APPENDIX B – Update Paper to Southern Area Planning Committee on 27 April 2021

APPLICATION NO.	20/00814/FULLS
SITE	Woodington Solar Farm, Woodington Farm, Woodington Road, East Wellow, SO51 6DQ, WELLOW
COMMITTEE DATE	27 April 2021
ITEM NO.	9
PAGE NO.	64-106

**Detailed Landscape Proposals
Central/DNO Substation and Solar Farm
Woodington Farm, East Wellow**

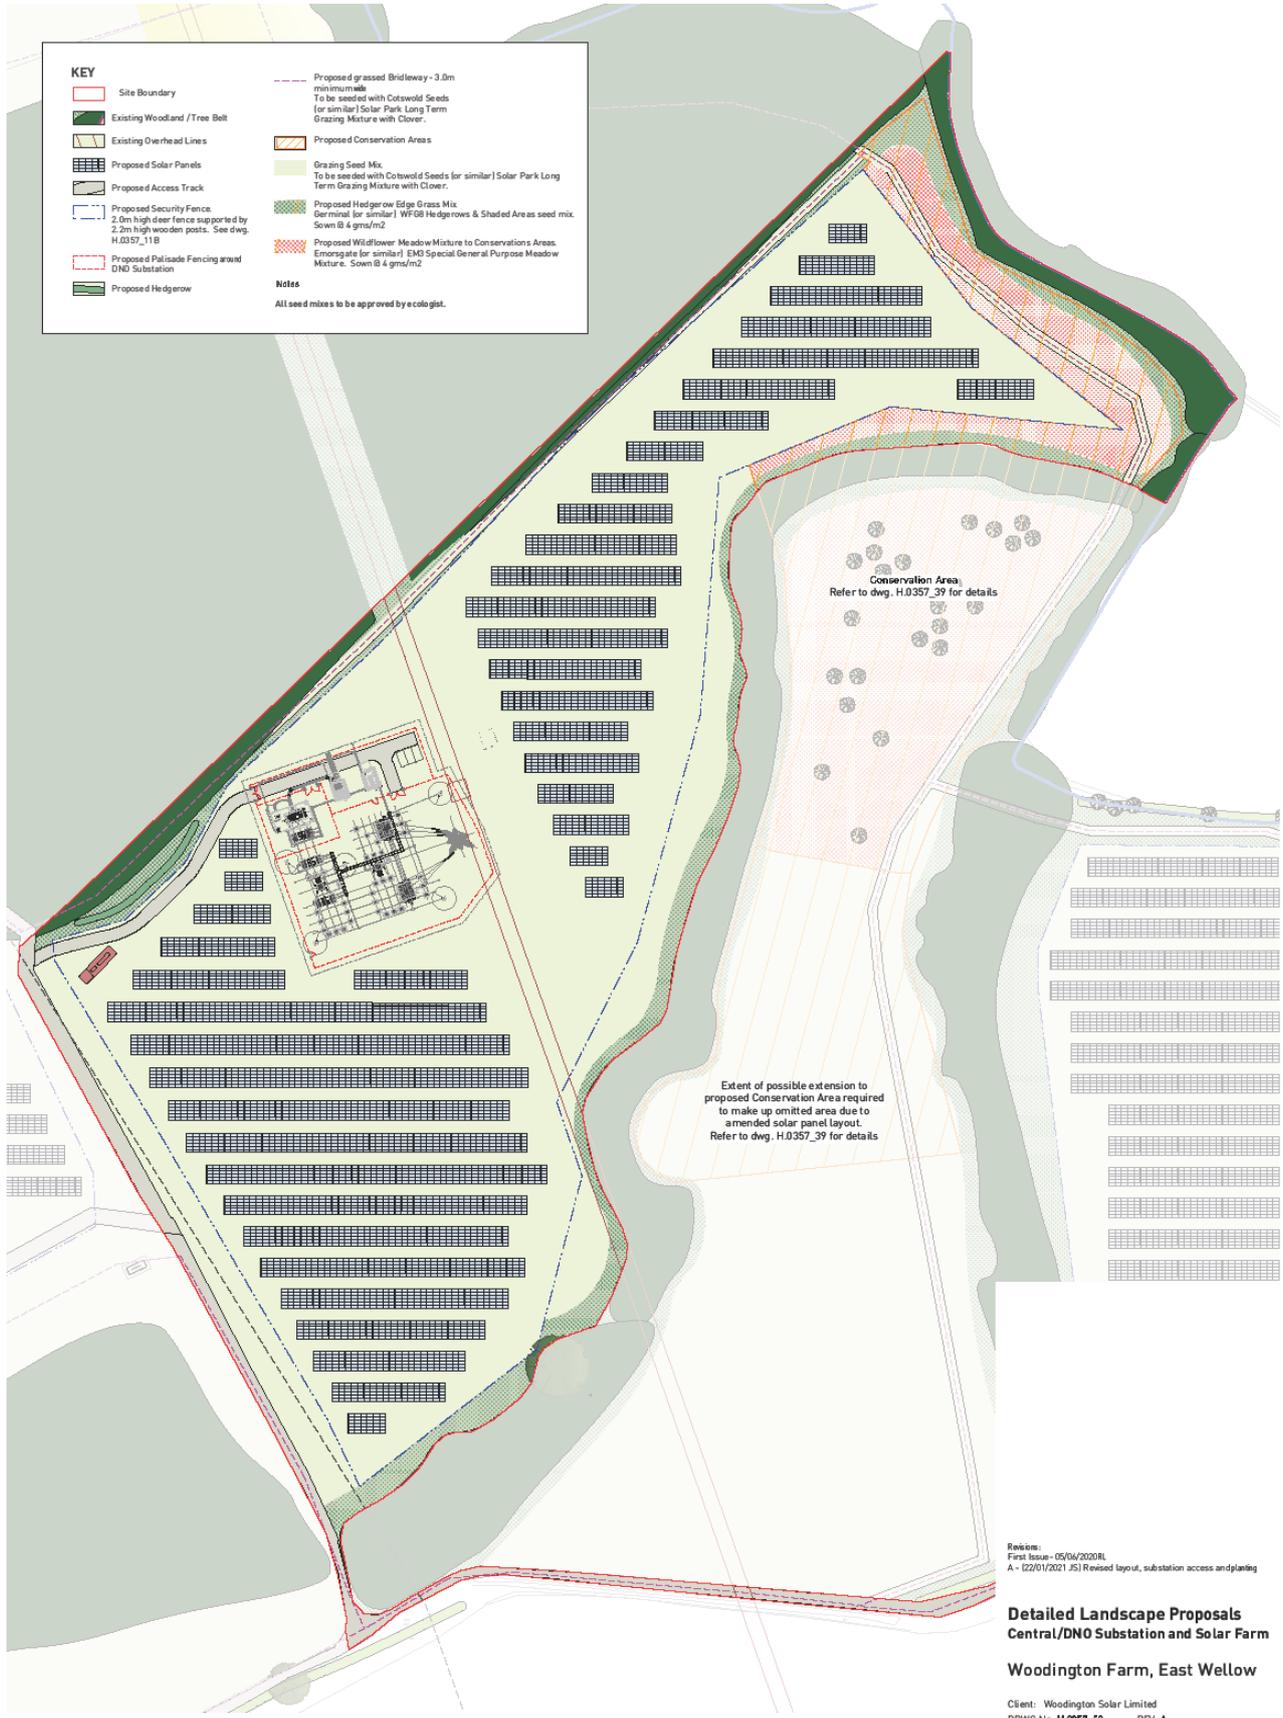
7. The development hereby approved shall be undertaken in full accordance with the provisions set out within the Pegasus Landscape Maintenance Plan and addendum B dated June 2020 and February 2021, the detailed landscape proposals set out on drawing no H.0357_50 A and the Woodington Farm Planting Schedule, Site Layout Plan (Drawing number H.0357_06-P) (Pegasus Environmental, 22.12.2020). Thereafter, mitigation and enhancement features shall be permanently maintained and retained in accordance with the approved details, with photographic evidence provided to the Local Planning Authority within 6 months of completion.
Reason: To improve the appearance of the site and enhance the character of the development, and to assist in the development successfully integrating with the landscape, in the interest of visual amenity, whilst ensure the favourable conservation status of protected sites, habitats and species in accordance with policies E1, E2 and E5 of the Test Valley Borough Revised Local Plan 2016.
